STAFF REPORT: 10/13/2021 MEETING

APPLICATION NUMBER: #21-7516

ADDRESS: 3747 TYLER (AKA 3745-3747 TYLER)

SCOPE: GENERAL REHAB, DOORS/WINDOWS INSTALLED WITHOUT APPROVAL

Site Photo 1, by Staff September 30, 2021: (North) front elevation.

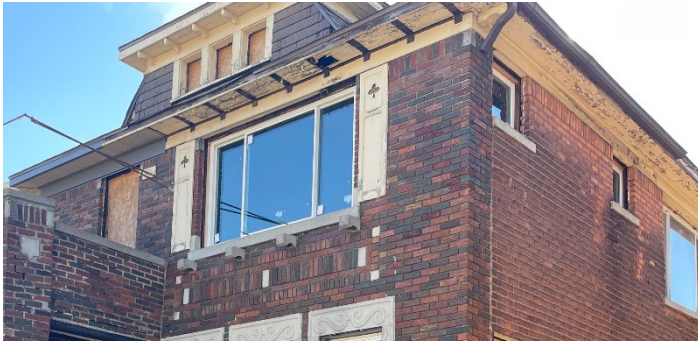
Site Photo 3, by Staff September 30, 2021: (Northwest) front/side elevation showing eave brackets removed, vinyl soffits partially-installed brown metal flashing on fascia board, door removed, and windows replaced.

- The removal of roof brackets along the eaves.
 - The removal of the front elevation’s 3rd floor windows, 2nd floor door, five (5) double-hung windows, and 1st floor, three (3) double-hung windows with transoms.

- It is staff's opinion that the removal of the roof brackets along the eaves, removal of original windows, removal of rear and side doors to be replaced with vinyl windows/siding/paneling, and removal of original rear porches has destroyed the original *scale, design, and materiality* of the this historic property, and therefore does not meet the Secretary of the Interior's Standards for Rehabilitation.

Staff finds that the removal of the eave's brackets, covering soffits and fascia with vinyl or metal, replacement of nineteen (19) original windows with vinyl windows, removal of rear and side doors and replaced with vinyl panel/siding/windows, removal or rear porch/balcony, destroys the historic character of this property and removes distinctive, character-defining features.
